**Before the Board of Zoning Adjustment of the District of Columbia
Appeal of Kalorama Citizens Association
BZA Appeal No. 17109**

Appellant's Statement

Report of Don A. Hawkins, Architect
February 2, 2004
BZA Appeal 17109

Observations on the Drawings for 1819 Belmont Road, N.W.

**SECTION SHOWING REVISED
 PARAPET AND BUILDING
 HEIGHT WITH ROOF STRUCTURE
 AS PERMITTED AND BUILT**

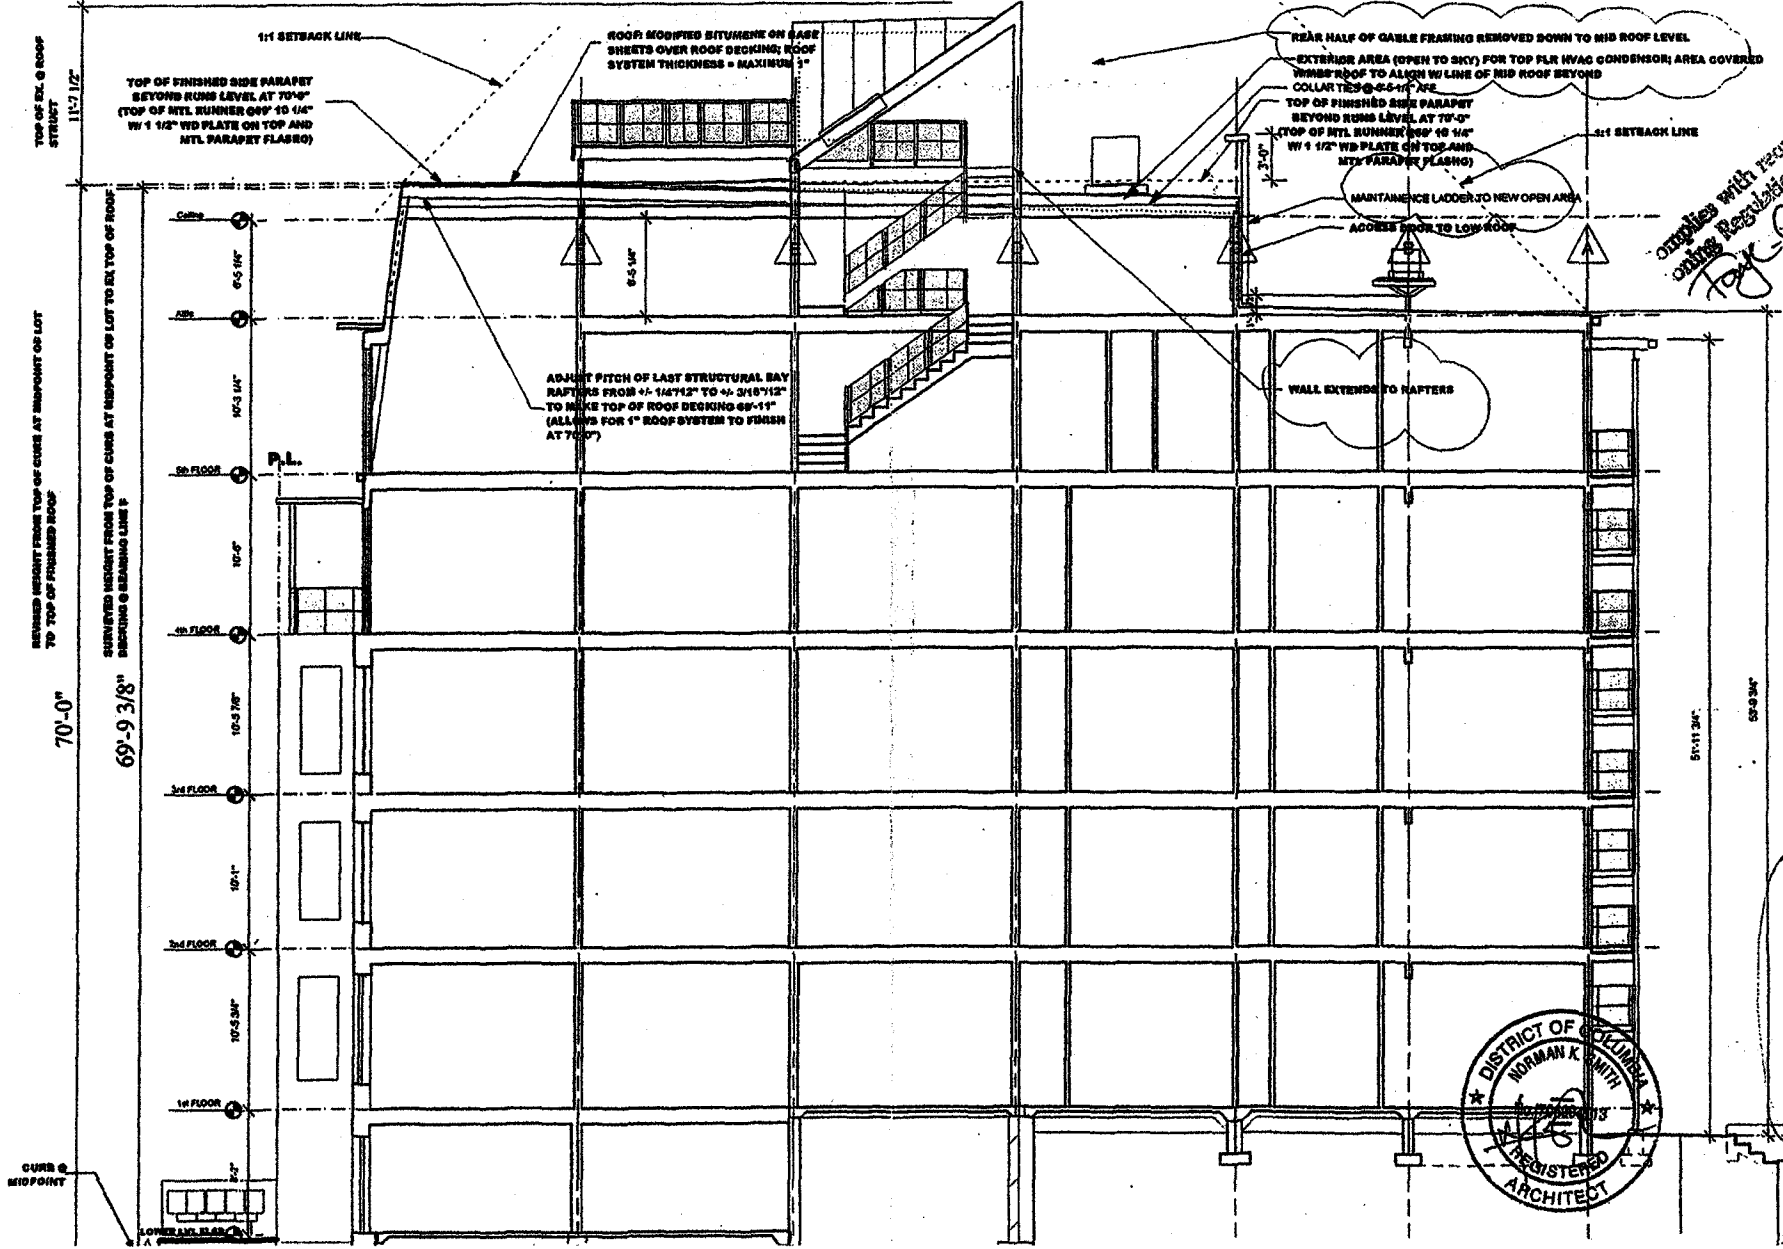
The revised plans depict a roof deck and balustrade or banister at the front of the building extending by several feet above the roof (see Exhibit 6). These structures are not among the several types of structures and embellishments enumerated in either the Height Act (§6-601.05(h)) or the Zoning Regulations (11 DCMR §§400.3, 400.4, and 400.8) that may be erected on a roof and may, under stated conditions, exceed the allowable building height. Had the legislature intended initially or at any time thereafter to include roof decks and their balustrades in the list of such excepted structures it could have done so. It did not. These structures on the subject property would therefore violate the Height Act and may not be authorized by special exception or otherwise.

(2) Roof structure setback. *The roof structure called for by the plans does not meet the requirement of the Height Act (DC Official Code §6-601.01 et seq.), 11 DCMR §400.7 and 11 DCMR §411.2 that it be set back from all exterior walls by a distance at least equal to its height above the roof.*

The roof structure called for by the original and revised plans, and now erected, is a penthouse for the purpose of enclosing the opening onto the roof of a stairway between the roof and the “attic” level immediately below. Unlike roof decks, a penthouse is on the list of roof structures that are permitted to exceed the allowable height under the Height Act and the Zoning Regulations (see above), but is subject to certain conditions, including the requirement that it “be set back from all exterior walls by a distance at least equal to its height above the roof upon which it is located”. In this case, the roof structure is 11 feet 7-1/2 inches in height. It appears to be set back by the requisite distance from the front wall and the rear wall. The west wall of the roof structure, however, appears to be set back only about 6 feet from the

west side wall of the building, and its east wall is flush with the east side wall of the building. (See Exhibit 7) Consequently, in our view the roof structure is set back as required by the Height Act and the Zoning Regulations from only two of the building's four exterior walls. It does not meet the setback requirement for the other two exterior walls.

ATTIC PLAN
Scale: 1/8" = 1'-0"

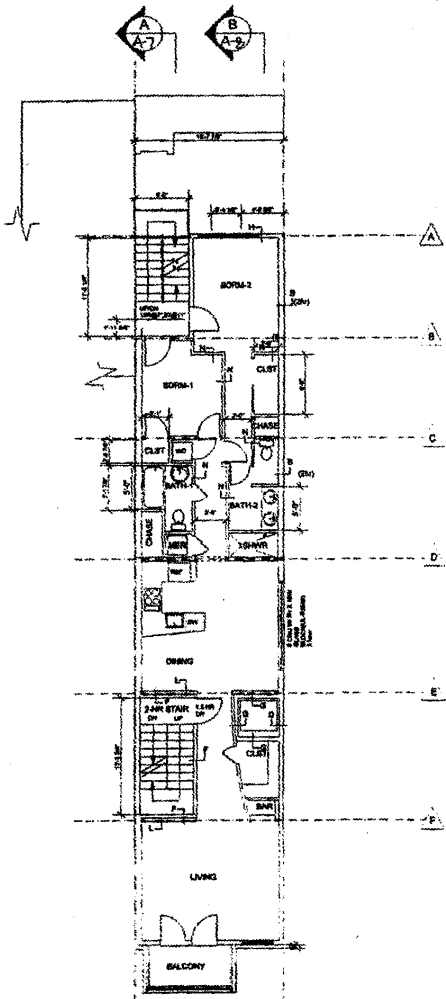
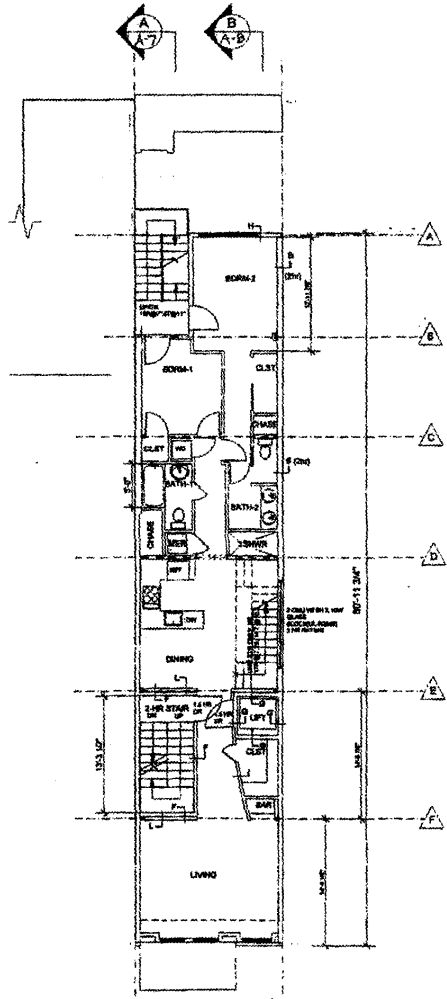
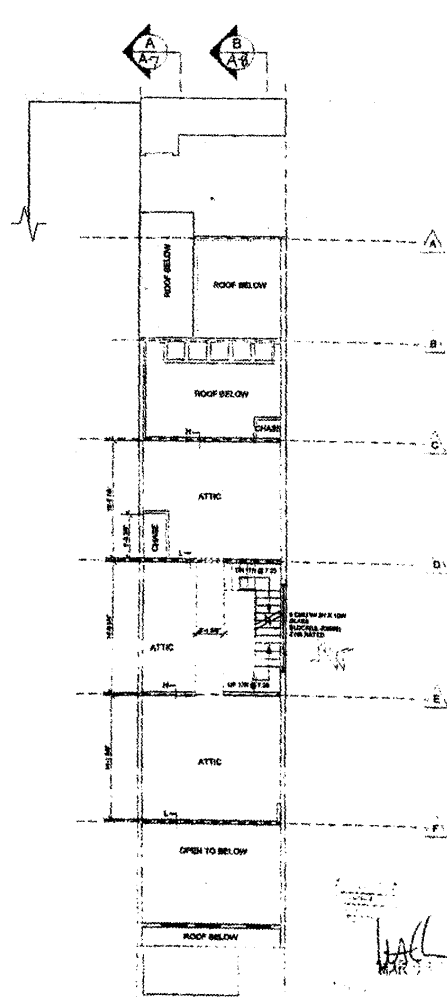
(3) **Excessive F.A.R.** *The portion of the building that the plans label as “attic” is not an attic under either the definition of “attic” contained in the BOCA Code (§1202.1), which we mention because it was invoked by the developers of this project in pre-permit*

It seems obvious that this feature (see Exhibit 6) was deliberately designed so as to evade the F.A.R. requirements and create additional valuable marketable living space in a high-end, three-level top apartment—in a building now being advertised as “bold and beautiful lofts”. This space will command the highest views of any space in the house, through the large south-facing false-dormer windows. It will have more than ample light from that direction as well as from windows to the east and west, for which provision has been made in the walls as constructed, if not in the plans. It will look out over the floor below at the front of the apartment like a mezzanine (Exhibit 8). It is connected to both the level below and the roof level above by a full staircase. It is an integral part of the living space of the apartment in which it is located.

Adding this valuable space was to be achieved by describing its headroom as 6 feet 5 –1/4 inches--just below 6 feet 6 inches--which, in the case of an attic, would exclude the space from gross floor area calculations (see 11 DCMR §199.1, definition of “gross floor area”). It appears to have a total of approximately 700 square feet of floor area, sufficient to exceed the maximum 3.5 total F.A.R. as calculated by the developers (Exhibit 9).

There are two problems. *First*, this space is not an attic. Webster's Unabridged Dictionary, maintained in the Zoning Office, defines “attic”, in relevant part, as: “the part of a building immediately below the roof and wholly or partly within the roof framing.” The BOCA Code, in 12 DCMR §1202.1, relied on by the developers (Exhibit 10), defines “attic” as: “The space between the ceiling beams of the top story and the roof rafters.” The real attic in this building, according to these definitions, is the space between the rafters supporting the roof and the ceiling beams of the level immediately below, space of no more than a foot in height at the front tapering to nothing at the rear. You can't make a space an attic simply by lowering its headroom and labeling it “attic”. For this reason alone--and leaving aside both the evident intended use of the space as living space, and the headroom—it is not an “attic” and thus its floor area must be included in the calculation of F.A.R., since it is one of the “several floors” of the building referred to in the definition of “gross floor area” in §199. Its inclusion appears adequate to take the total F.A.R. well over the allowable limit.

Second, even if this space were an attic, it would have to be included in calculating gross floor area, because the 11 DCMR §199 definition of “gross floor area” requires inclusion of attic space providing *structural* headroom of six feet, six inches (6 ft., 6 in.) or more”. It appears clear from the plans that the proposed 6 foot 5-1/4 inch ceiling is not structural, but simply a (presumably) drywall ceiling mounted on structurally unnecessary collar ties attached to the roof rafters. It could be removed without affecting the structural integrity of the building, perhaps to be replaced by some tall future owner with one mounted directly on the underside of the roof

rafters. The structural headroom, as evidenced by the height of the roof rafters, is clearly well in excess of 6 feet 6 inches.

Attic: By definition an attic is the space between the top of the ceiling joists of the uppermost story and the bottom of the roof rafters. The only space shown on the Drawings that conforms with the definition of an attic is the small sliver of space less than a foot high at the front of the house.

The ceiling joists are not structurally necessary for the strength or stability of the roof. In the back portion of the "Attic", collar ties are indicated at 4'-0" on center. They are not performing any necessary function and could be removed without weakening the structure in any way.

Not being required, the ceiling joists could easily be removed by a future owner to achieve a higher space and thereby raise the habitable floor area above the allowable.

ROOF DECK PLAN
Scale: 1/8" = 1'-0"

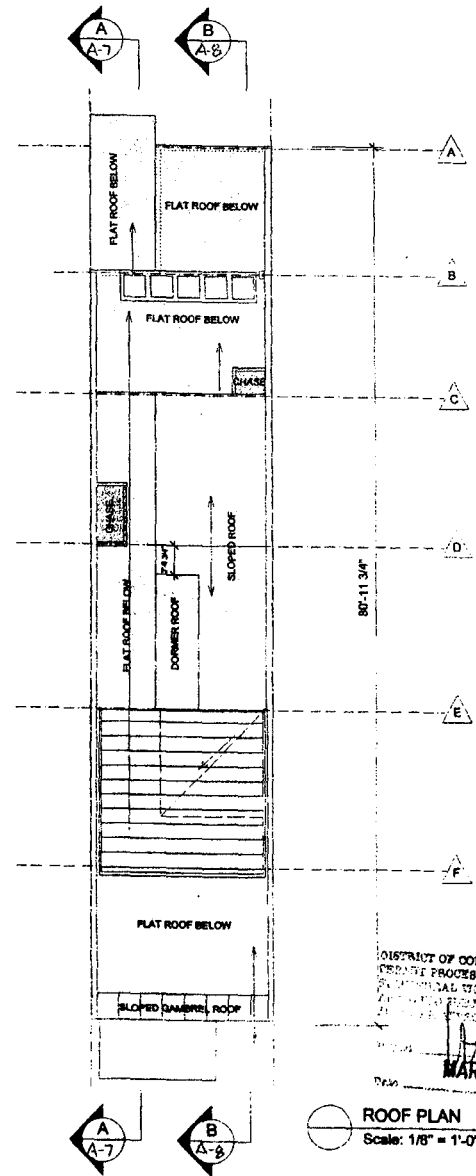
Roof Deck and stairway to the roof: The roof deck exceeds the height limit of 70 feet. It does not qualify as a roof structure under the Height of Buildings Act. The stair to the roof is not needed without the deck. **Conclusion:** The roof structure with its stairway should be eliminated, for access to the roof for maintenance purposes could be provided by ladder from the lower roof or a hatch.

Roof structure: If a roof structure is provided in compliance with the Height Act, it must be set back from all exterior walls by its height. This cannot be done in this instance because of the height of the roof structure, made higher because of its design in relation to the planned raised deck when applied to this narrow row house. It sits on an exterior wall, a party wall on one side. **Conclusion:** The roof structure, especially since it will not be needed without the deck, should be eliminated as not being able to be in compliance, as currently designed, with the Height of Buildings Act.
